## HISTORIC AND DESIGN REVIEW COMMISSION

September 18, 2019

**HDRC CASE NO:** 2018-533  
**COMMON NAME:** 335 TRAIL  
**LEGAL DESCRIPTION:** NCB 6078 BLK 2 LOTS 9 THRU 14 & 17 THRU 20  
**ZONING:** MF-33, H, RIO  
**CITY COUNCIL DIST.:** 1  
**DISTRICT:** River Road Historic District  
**APPLICANT:** Mark Odom, AIA/Mark Odom Studio  
**OWNER:** Robert Price  
**TYPE OF WORK:** Construction of a multi-family residential development  
**APPLICATION RECEIVED:** August 05, 2019  
**60-DAY REVIEW:** October 04, 2019  
**CASE MANAGER:** Edward Hall

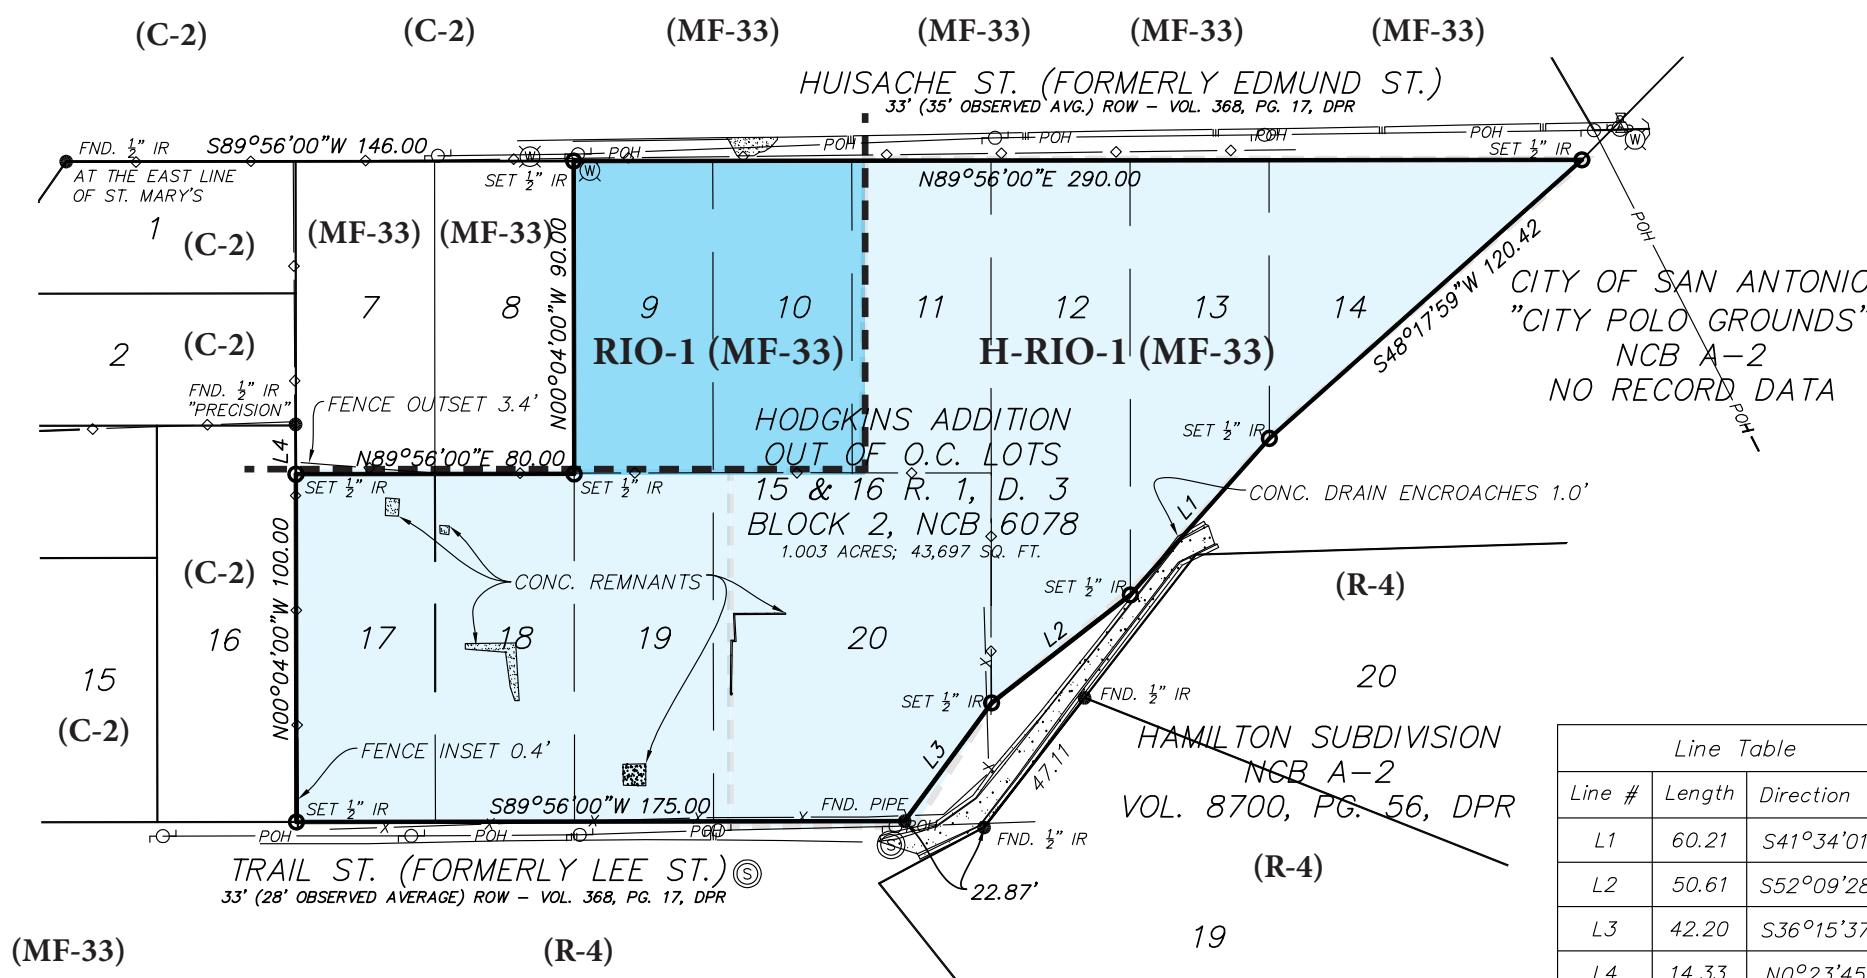
- iii. That the applicant incorporate porches or distinct entrance elements as noted in finding p.

**We will comply with this recommendation**
